# UNITED STATES PATENT AND TRADEMARK OFFICE

10/552,951

William F. Ogilvie

<b>Office Action Summary</b>	<b>Application No.</b> 10/552,951	<b>Applicant(s)</b> OGILVIE, WILLIAM F.	
	<b>Examiner</b> JOSHUA LEVINE	<b>Art Unit</b> 4177

**Figure A from labels and dimensions the radius of the disk and the radius of curvature**

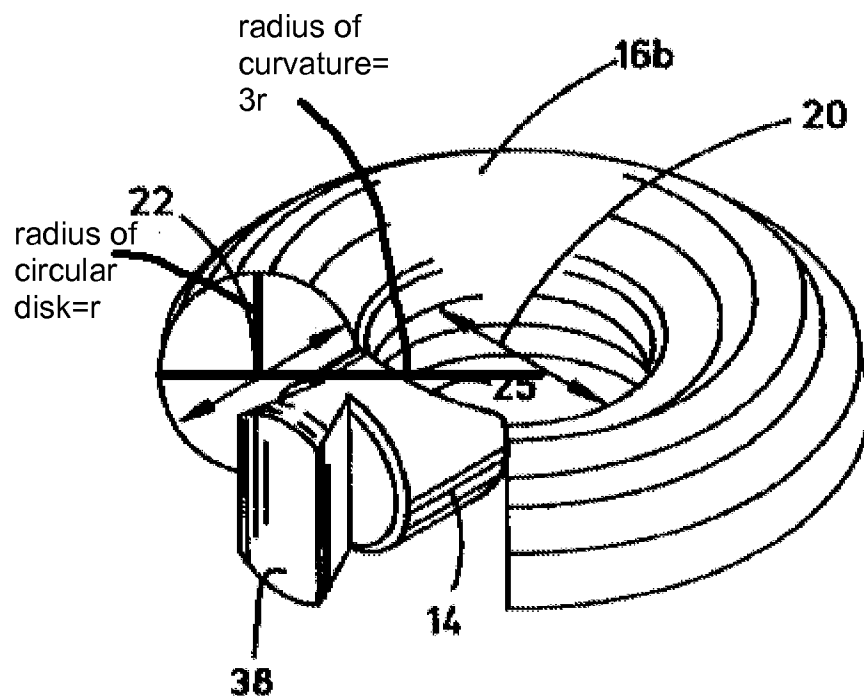
6. Regarding claim 6, Klawitter disclosed an implant where the convex spherical surface is at least about twice the radius of said circular disk and wherein said peripheral rim surface is a segment of a sphere. The disk radius 22 and the hole radius 20 have equal measurements (column 4 lines 20-23). Therefore, the radius of the curvature of the disk is three times circular disk radius 22 (see Figure A)
